ADDENDUM NO. 2
To the Contract Document and Project Specifications for the
JEFFERSON MIDDLE SCHOOL SITE IMPROVEMENTS
Fort Wayne Community Schools (FWCS)
Fort Wayne, Indiana
January 2, 2025

JEFFERSON MIDDLE SCHOOL PICKUP LANE
FORT WAYNE COMMUNITY SCHOOLS
1200 S CLINTON STREET
LANDSCAPE PLAN

DESIGNED BY: JPR TEAM
REVIEWED BY: NGD
DATE: DEC 09, 2024
JOB NUMBER: 2024-01328
HORIZ. SCALE: 1" = 30'
VERTICAL SCALE: N/A
C601

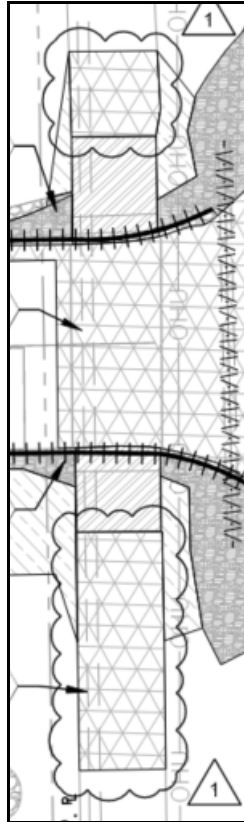
B. **REVISED:** Trail demolition along Wheelock Road to be full removal.

C. **REVISED:** Language for hatch calling for the removal of vegetation by FWCS.

2. Plan Sheet C201

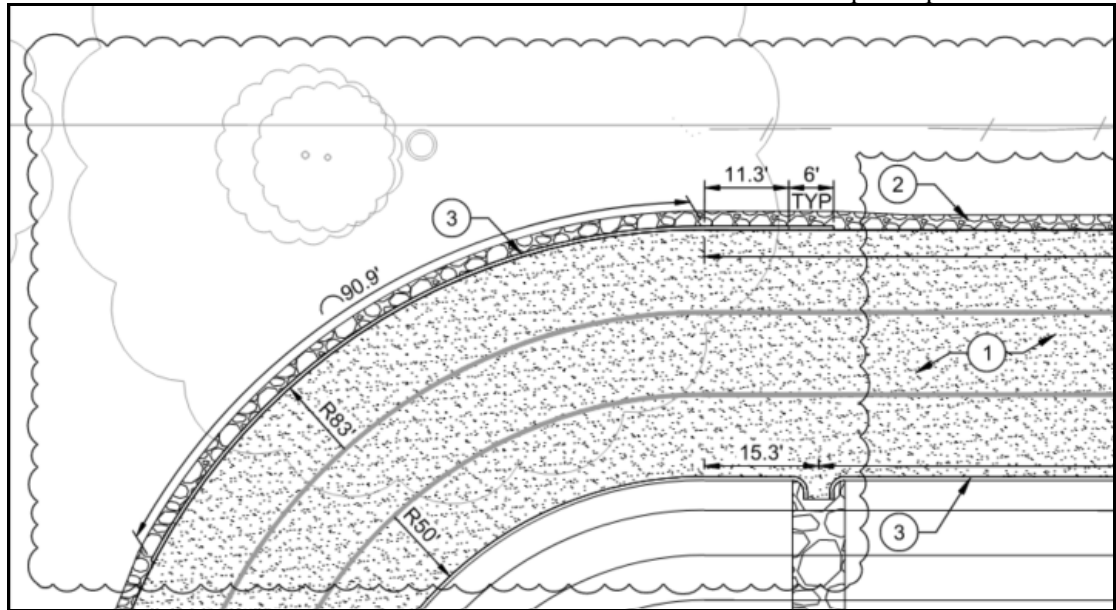
A. **REMOVED:** Keynote 4 in legend and on plan; there will not be a proposed fence along the northern edge of the property.

B. **ADDED:** Standard curb and dimensions on the northwest corner of the pick-up lanes.

3. Plan Sheet C301

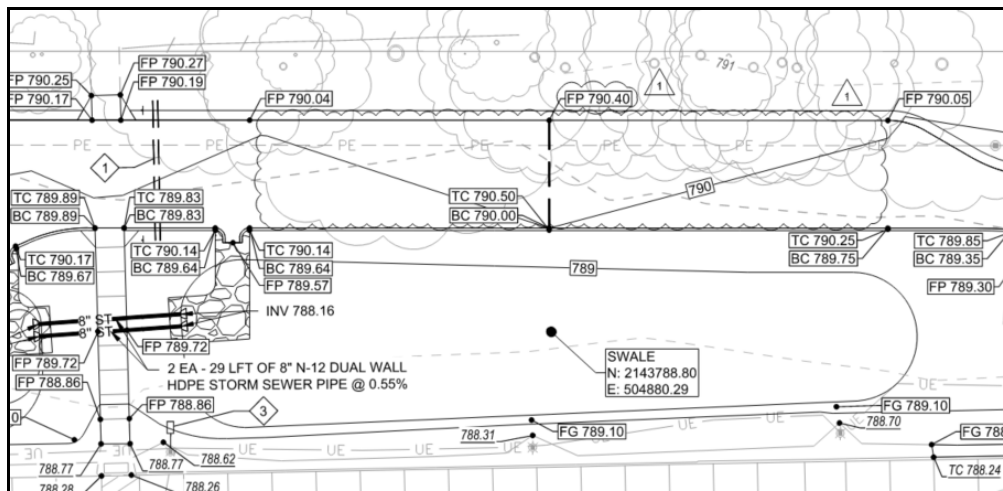
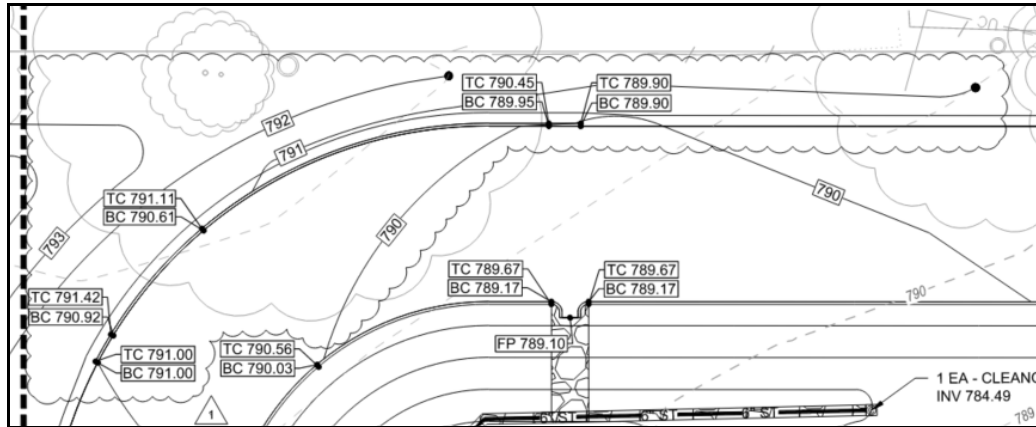
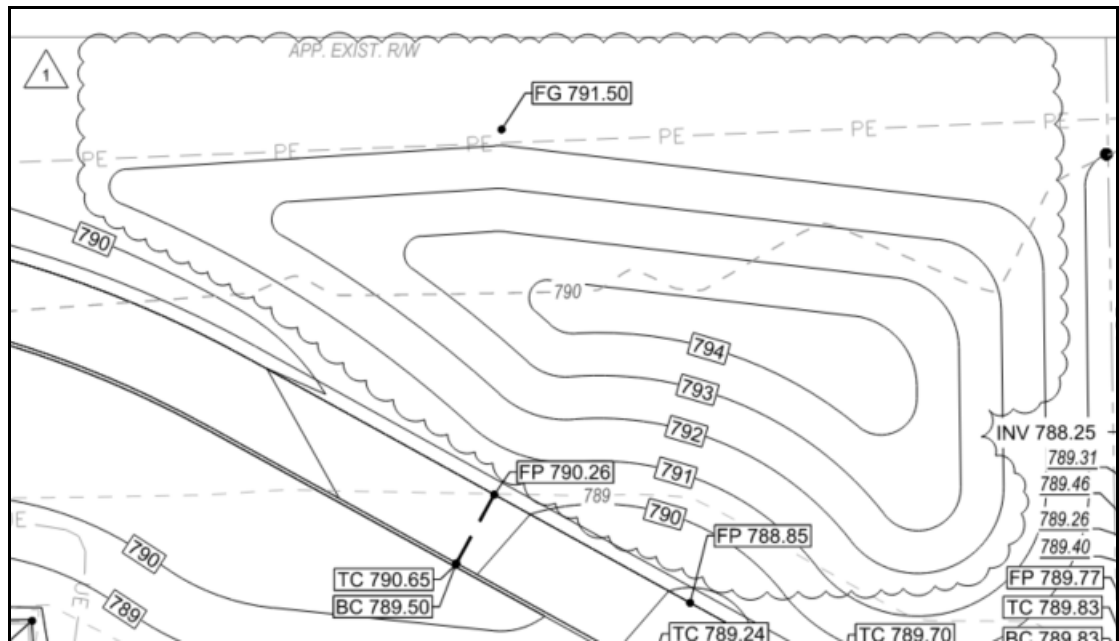
A. **REVISED:** Grades and contours on the northeast and northwest edges of the pick-up lanes.

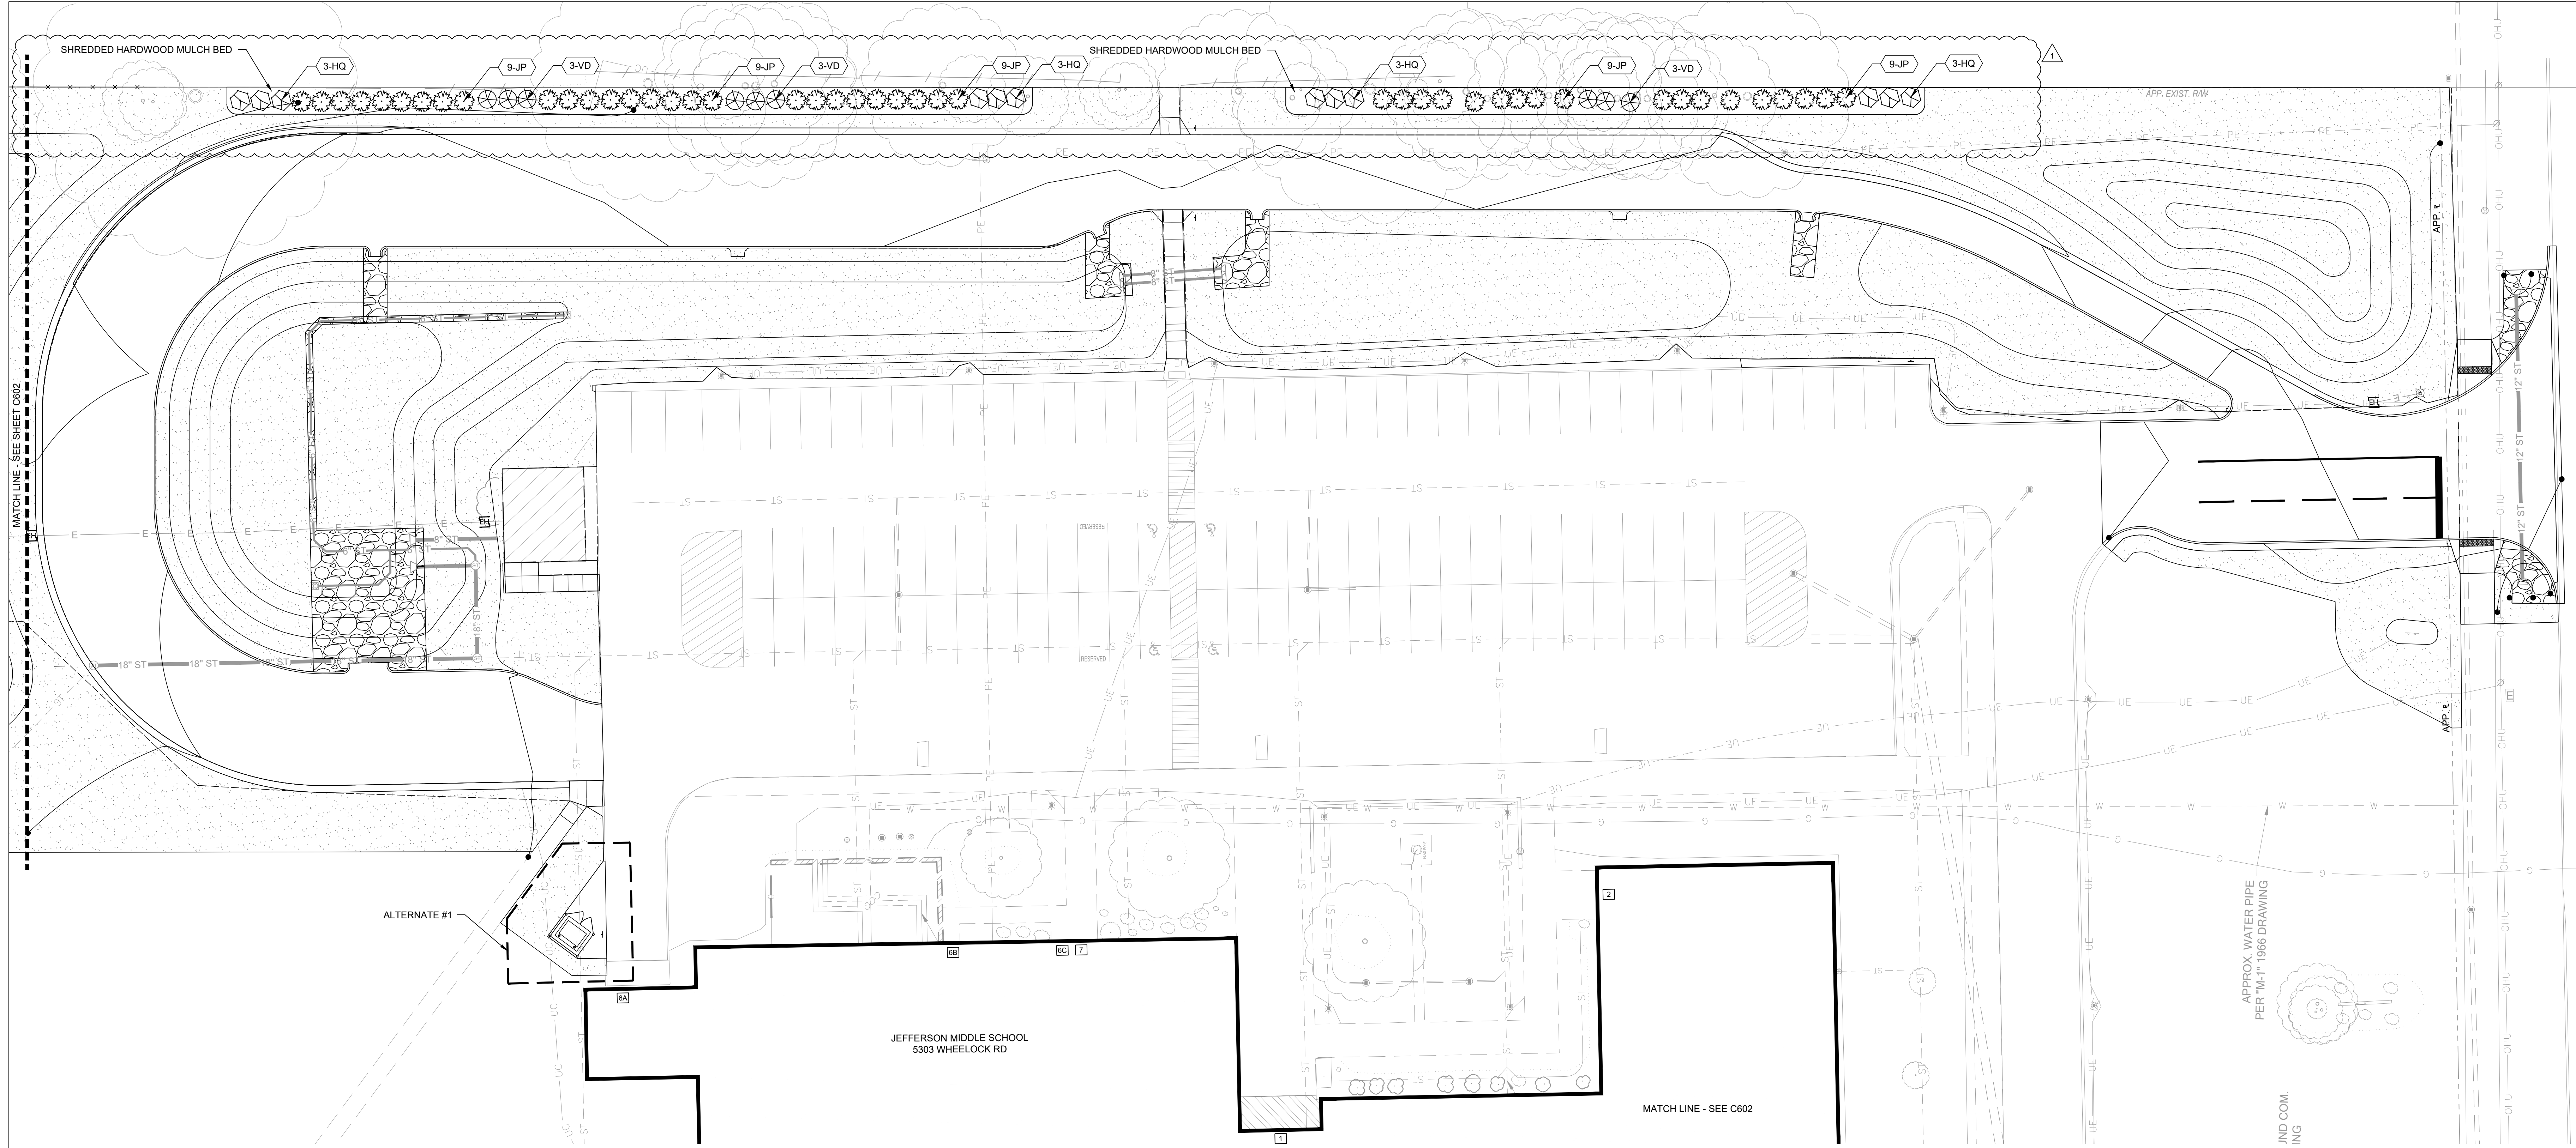
1. Are we supposed to remove the existing aggregate edge in the area on the northeast corner of the parking lot or do you want us to remove it for the new proposed aggregate edge?
 - A. *The slope of the aggregate edge from existing conditions to proposed conditions is being changed – refer to the grading plan. The aggregate edge does not need to be replaced full depth, a new layer of aggregate over top the existing stone edge in this area to meet the proposed grades and stormwater flow pattern is all that is needed.*

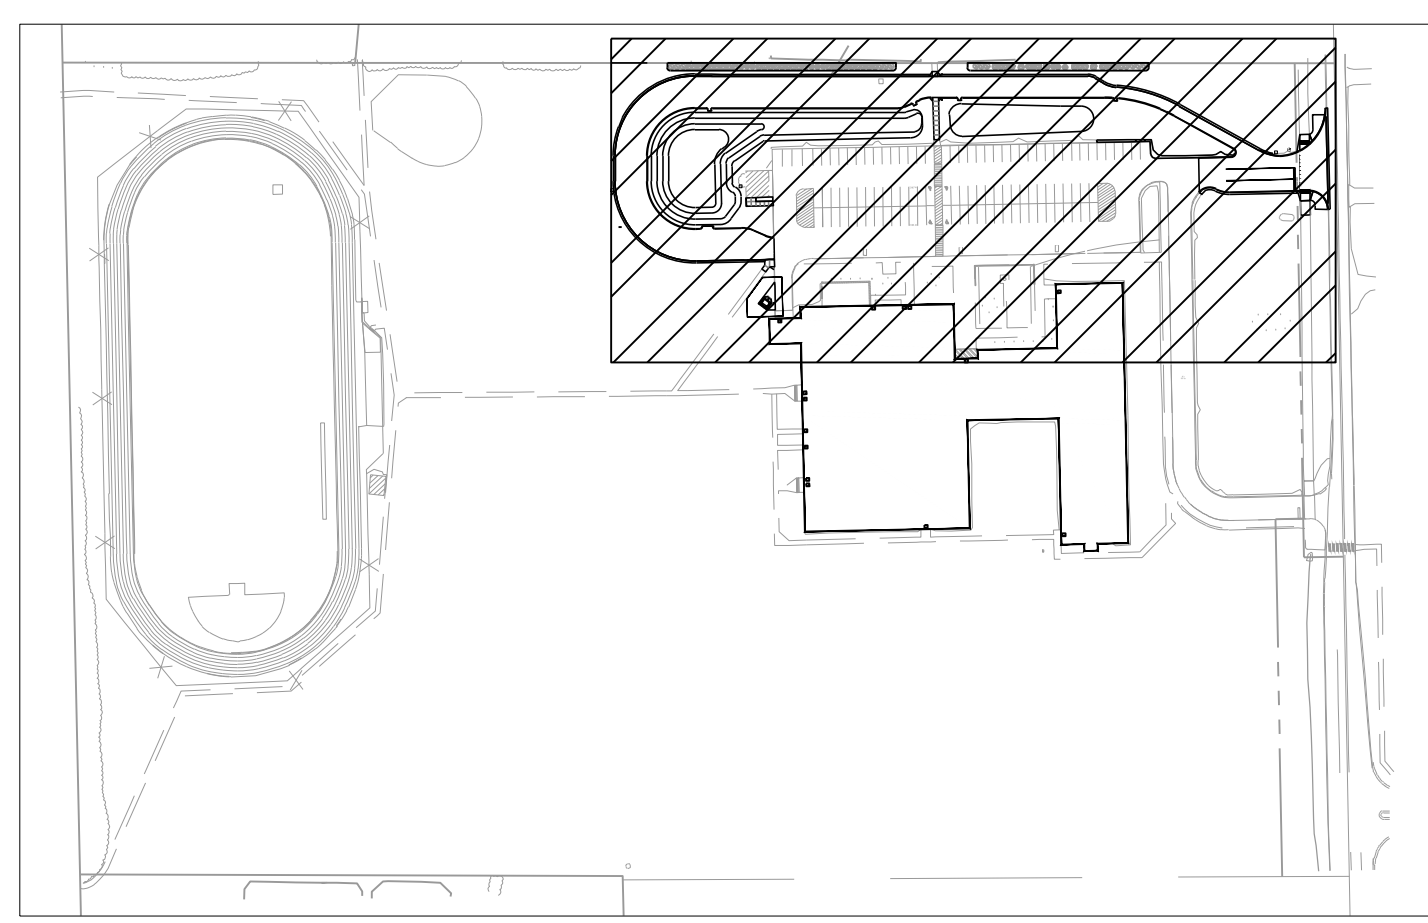
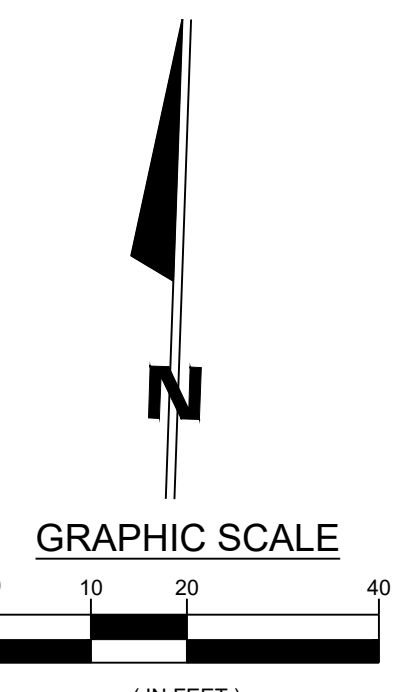
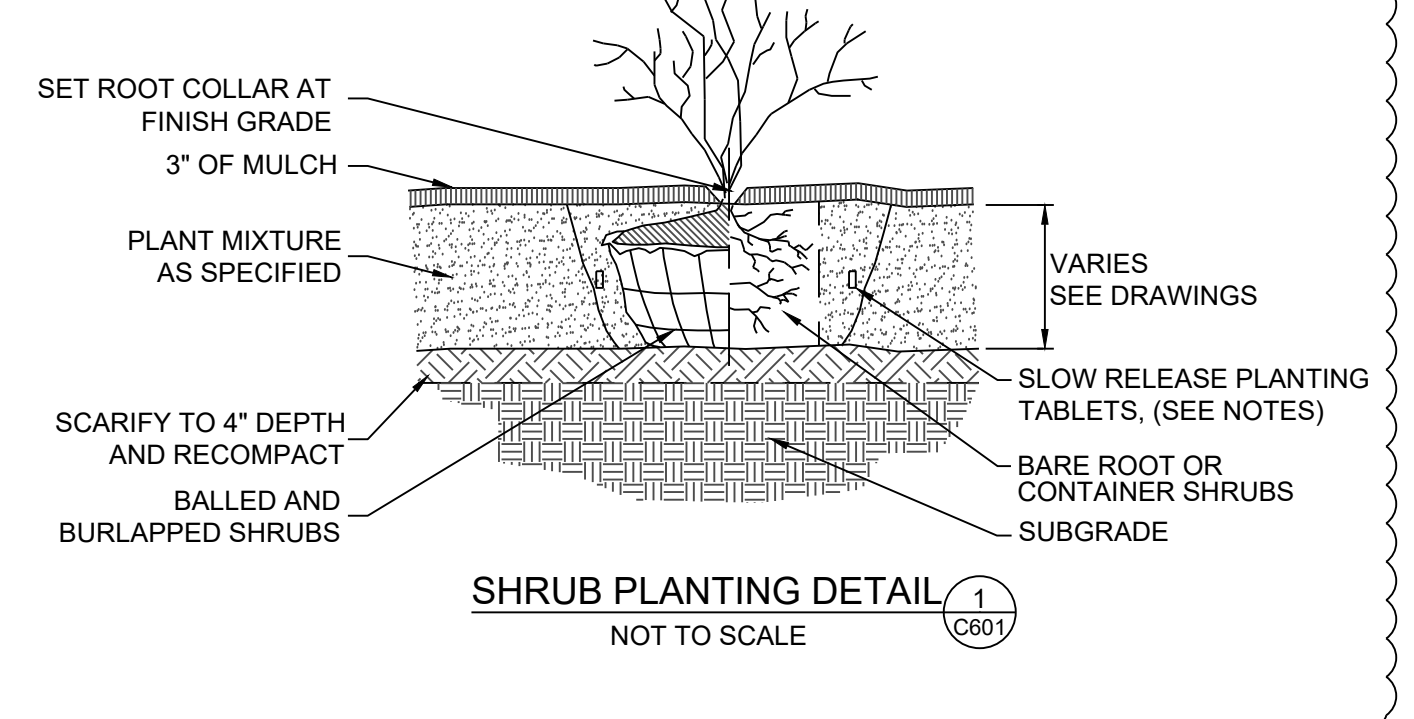
- A. **REVISED:** Landscape at the northern edge of the property; instead of the proposed trees, there will be shrubs with a mulch bed.
- B. **REVISED:** Detail 1/C601; shown as a shrub planting detail instead of a tree planting detail.
- C. **REVISED:** Plant material list to account for shrubs.
- D. **REVISED:** Note 8 in General Landscape Notes to account for shrubs instead of trees.
